**ADDENDUM NO. 2**

This addendum modifies the Contract Documents dated March 17, 2020, for the San Lorenzo Valley Water District 2020 Pipelines Replacement Project, and the work shall be accomplished in accordance with such modifications. This Addendum includes two (2) pages plus two (2) attachments (total of 4 pages).

- A. Sheet C6.1, Standard Details, the following detail is amended:

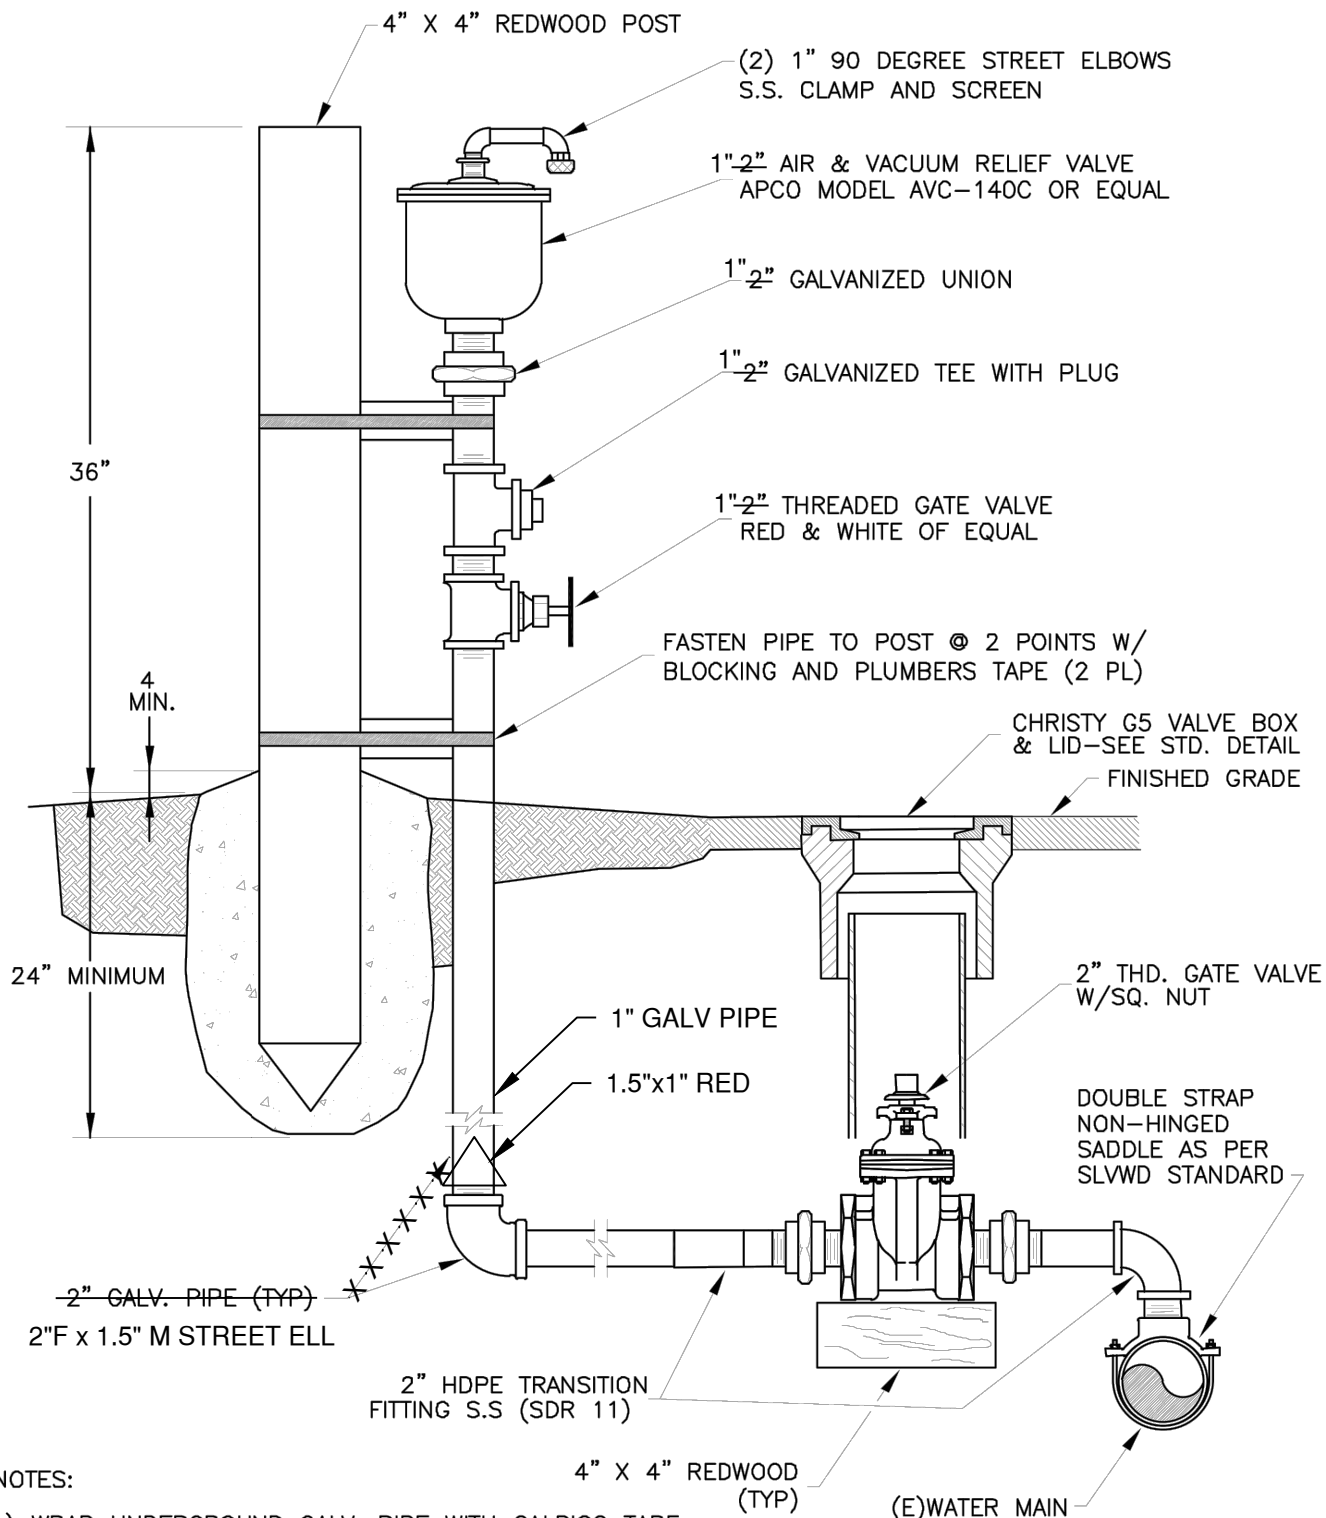
- A. Questions were received asking to confirm the quantities of several bid items.
  - a. Corrected quantities are provided on the revised Bid Schedule, included with this addendum. For Bid Item 7A, the bid quantity remains 2, for the two services shown on sheet C1.6.
- B. The Bid Schedule calls out 1" Air/Vac valves, but detail SD-7B shows a 2" ARV. Which size is required?
  - a. 1" ARVs are required. Sheet C6.1 is corrected as noted below.

Detail SD-7B: 2" Air/Vac Release with Gate Valve, is changed to a 1" ARV with 1" galvanized riser pipe (provided at Attachment 2). Note that the service saddle and gate valve remain 2-inch.
